HISTORIC ST. MARY'S CITY & ST. MARY'S COLLEGE OF MARYLAND

MARYLAND HERITAGE INTERPRETIVE CENTER PARKING LOT

DRAWN BY: ZJR CHECKED BY: PCS
 DATE: 12/09/2022 PROJECT #: 08038
 SCALE: AS SHOWN
 DRAWING NAME:
EXISTING CONDITIONS & DEMOLITION PLAN

PROPOSED SITE PLAN

DRAWING NO.: **C101**

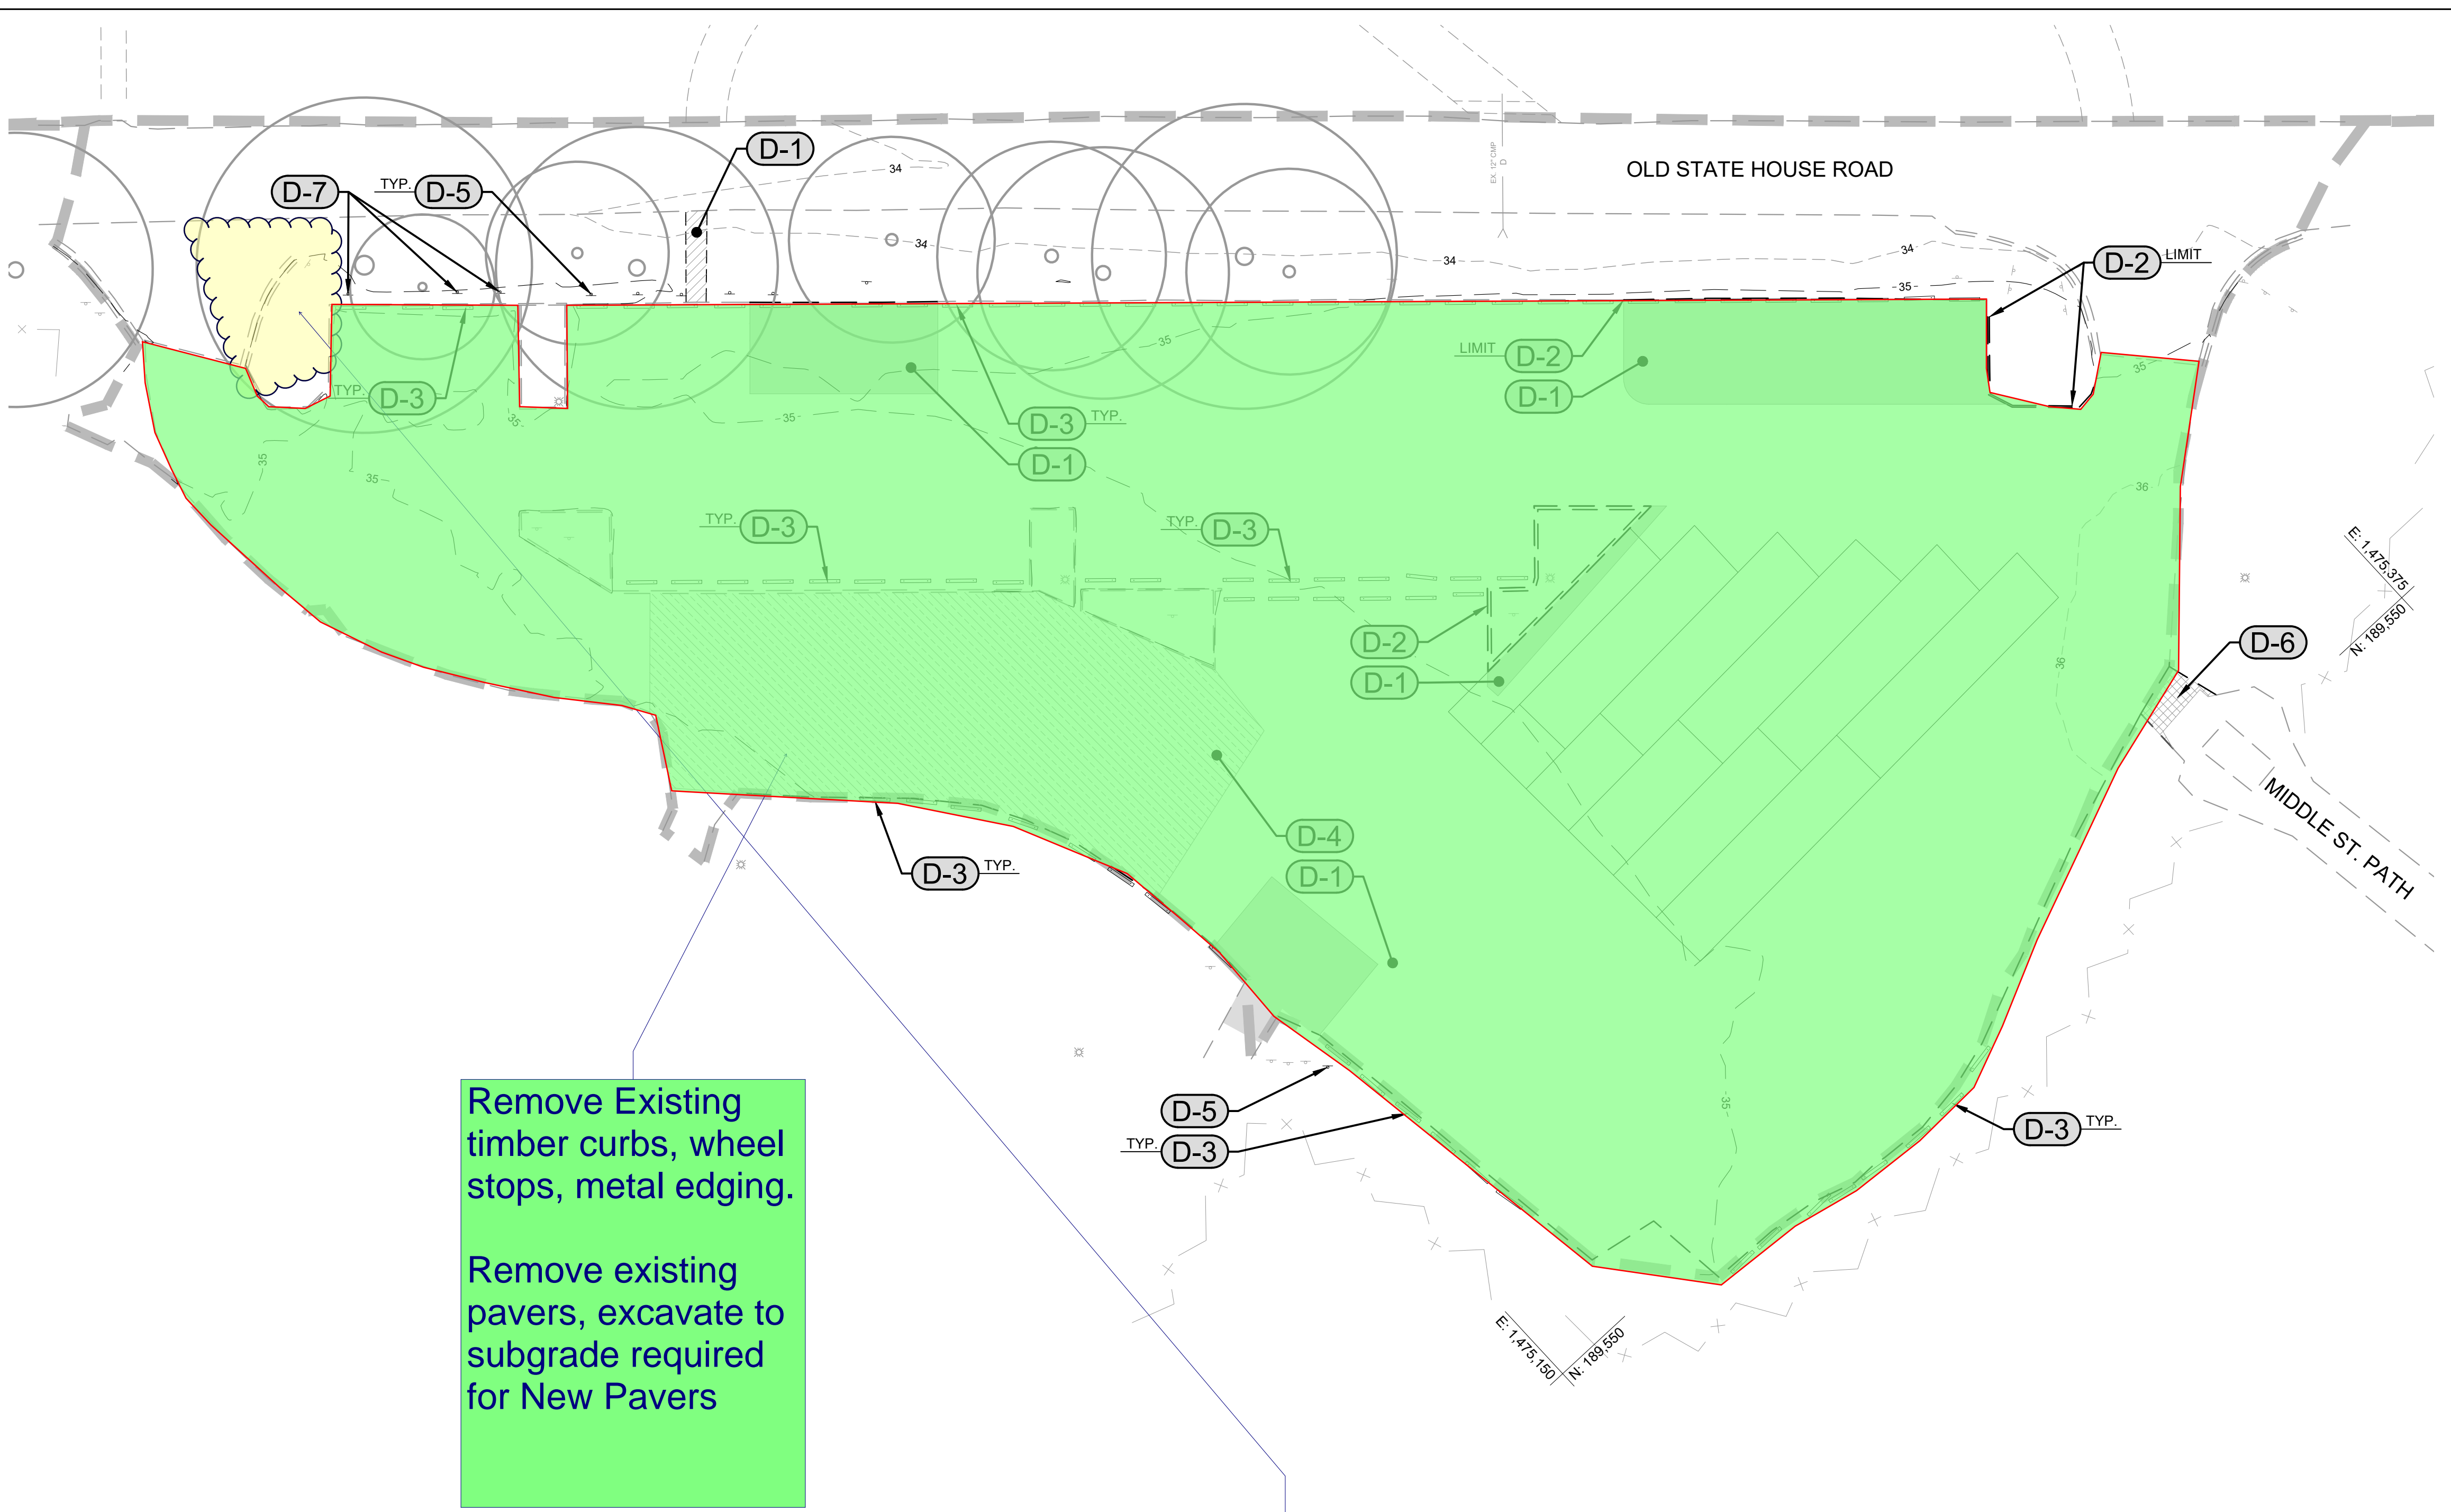
Remove Existing timber curbs, wheel stops, metal edging.
Remove existing pavers, excavate to subgrade required for New Pavers

Sawcut asphalt and Demo Existing Curb on one side to allow for 12 ft wider entrance

DRAWING NO.: **C111**

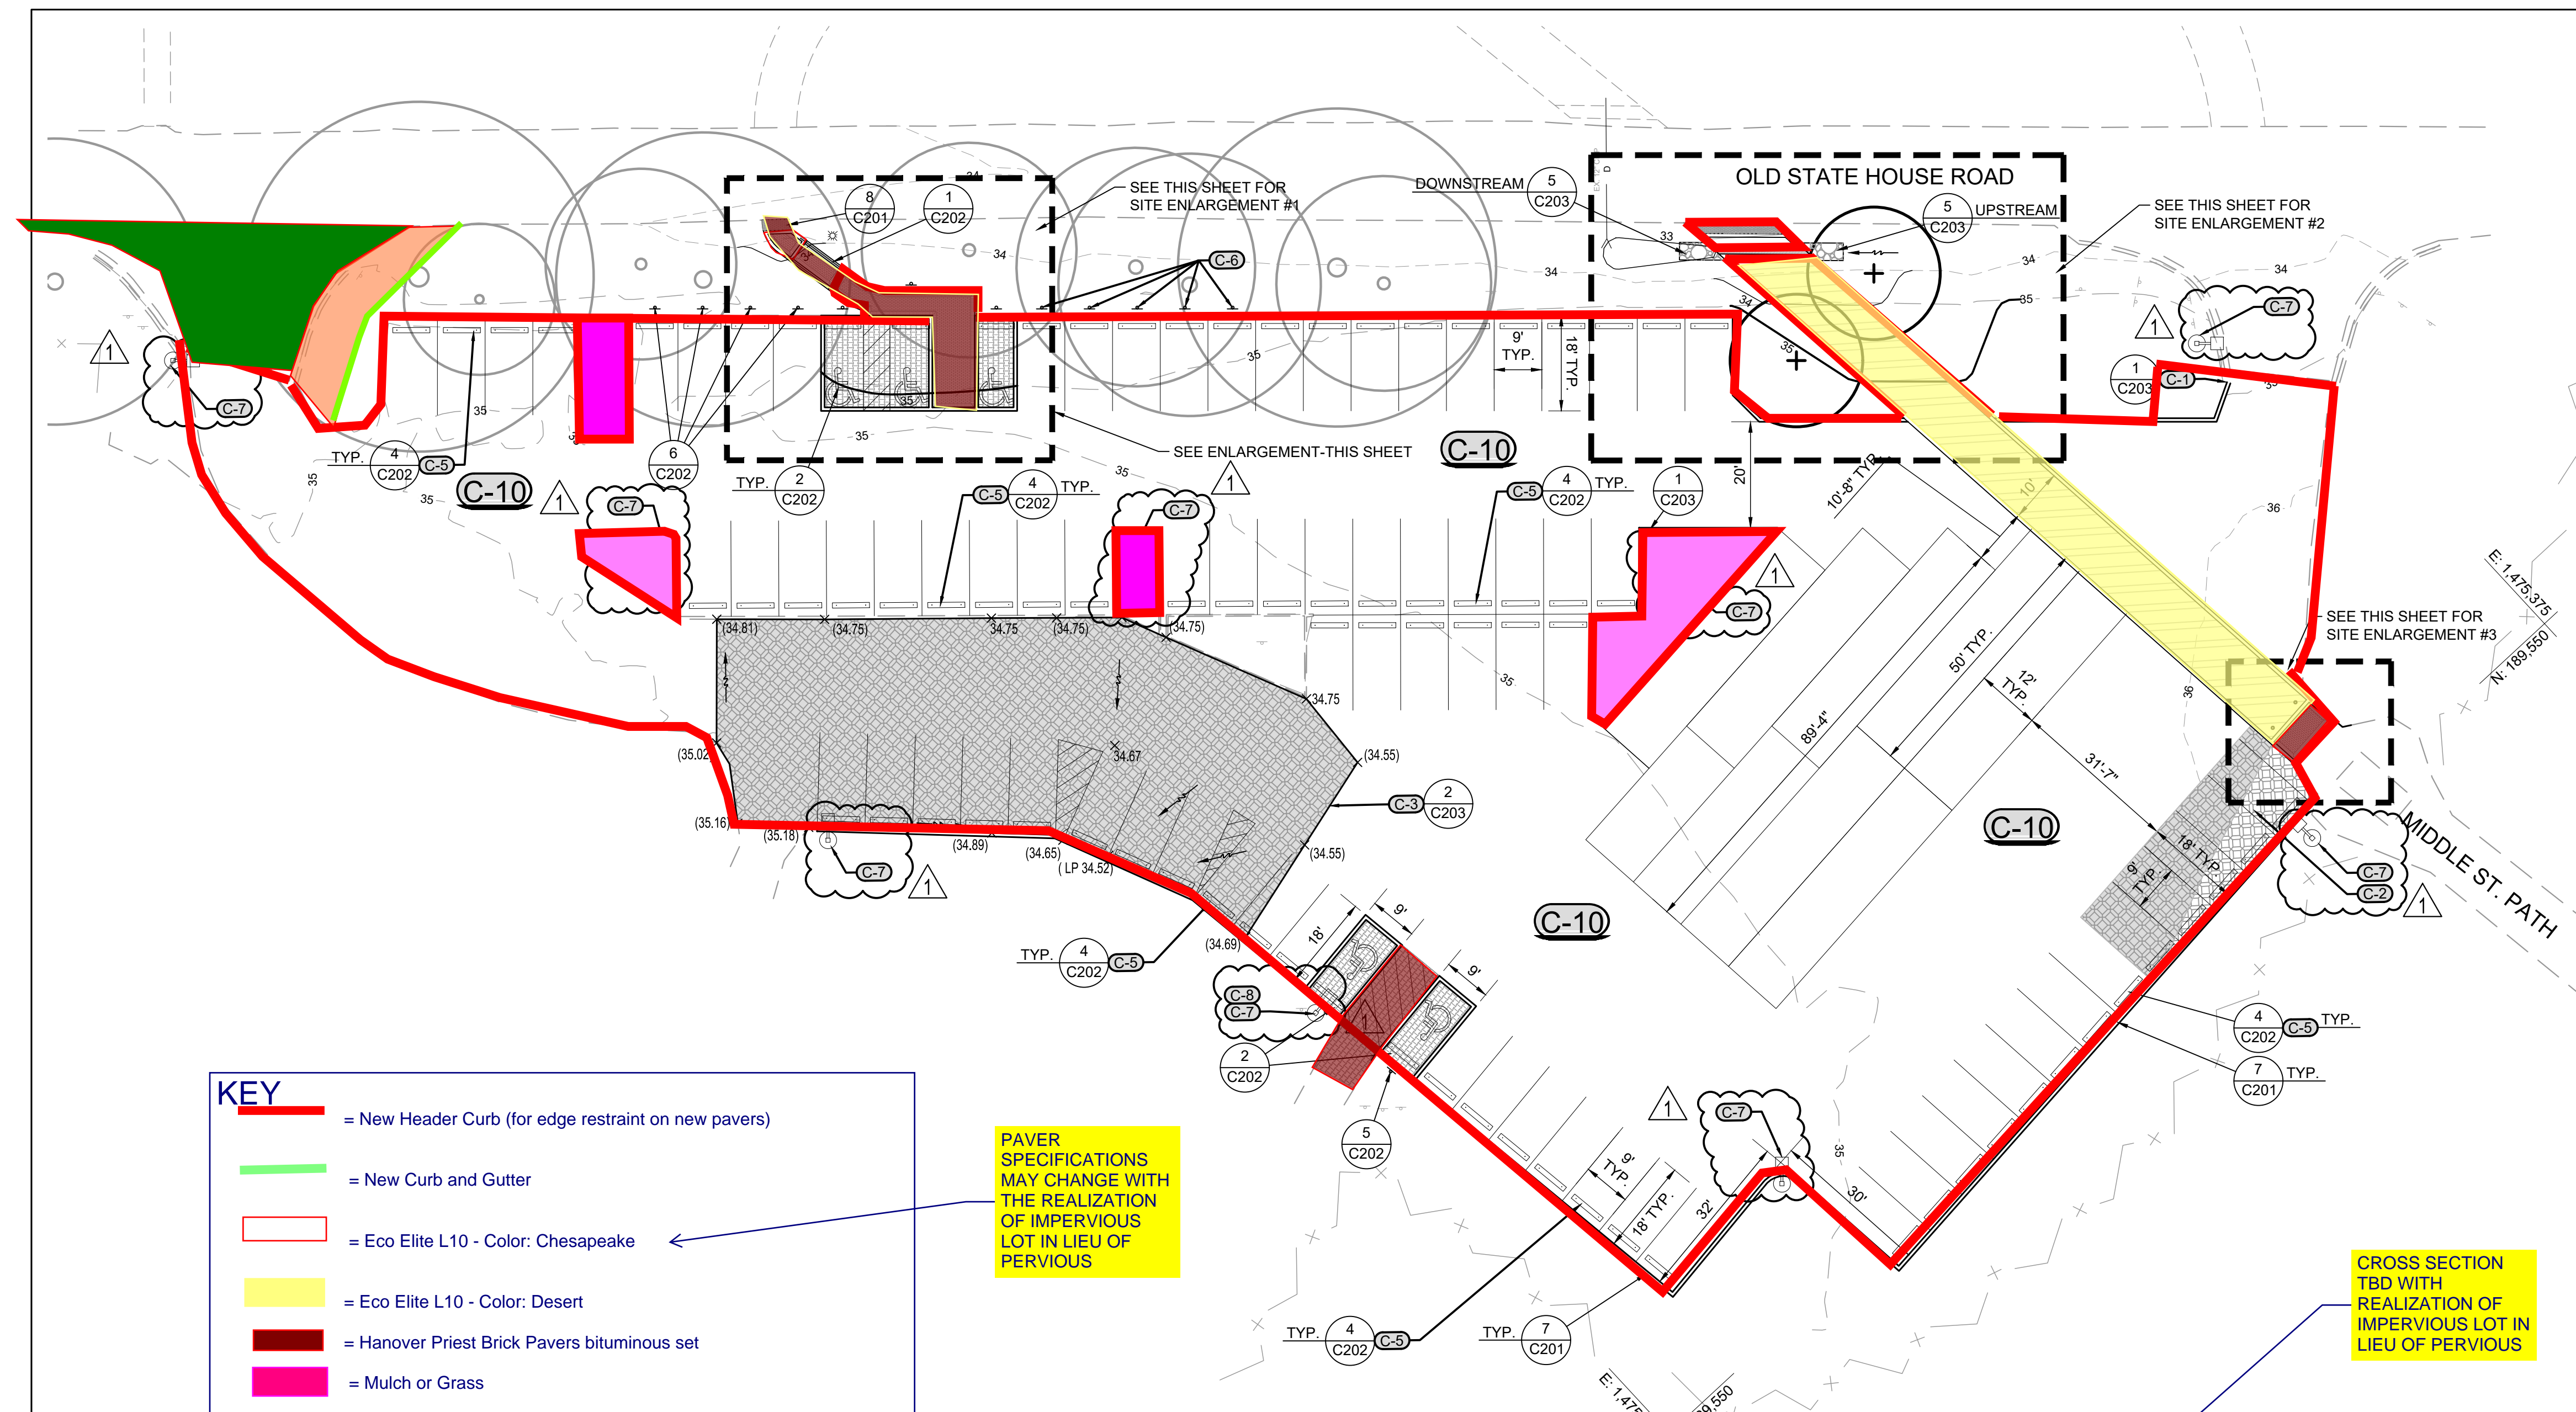
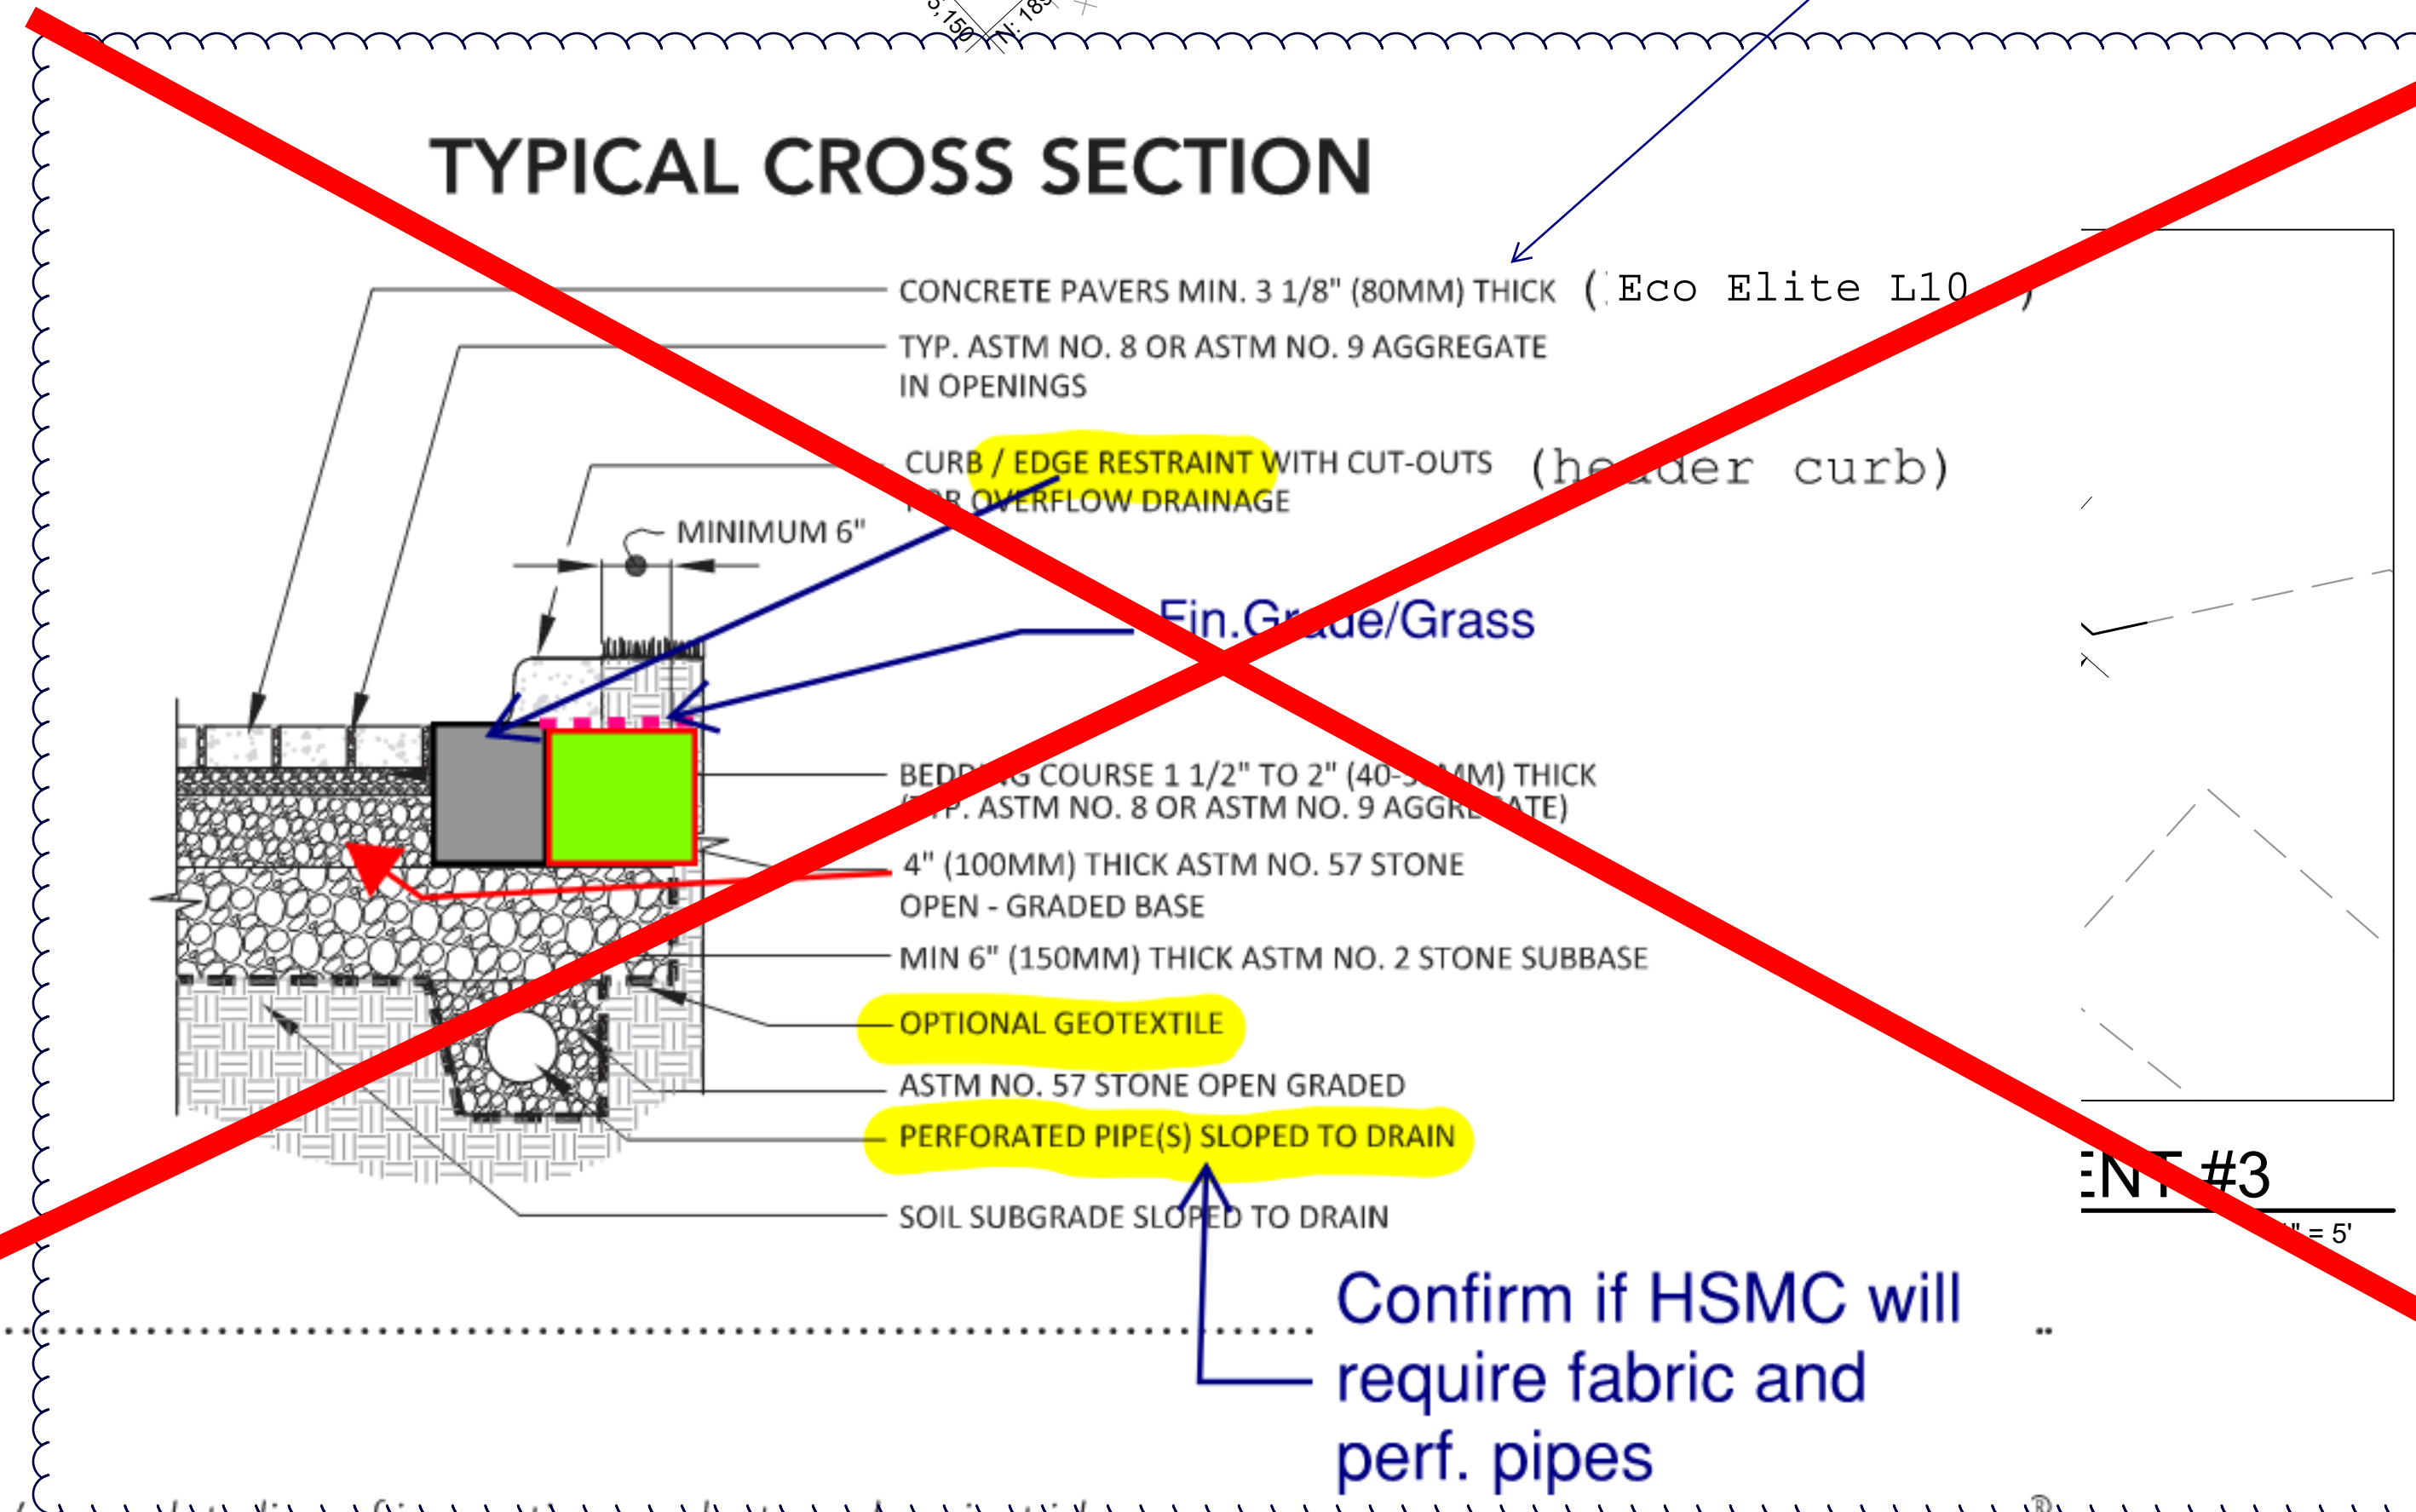
- = New Header Curb (for edge restraint on new pavers)
- = New Curb and Gutter
- = Eco Elite L10 - Color: Chesapeake
- = Eco Elite L10 - Color: Desert
- = Hanover Priest Brick Pavers bituminous set
- = Mulch or Grass
- = New Asphalt
- = Mill/overlay finish course, extend into new asphalt area

PAVER SPECIFICATIONS MAY CHANGE WITH THE REALIZATION OF IMPERVIOUS LOT IN LIEU OF PERVIOUS.

CROSS SECTION TBD WITH REALIZATION OF IMPERVIOUS LOT IN LIEU OF PERVIOUS

Confirm if HSMC will require fabric and perf. pipes
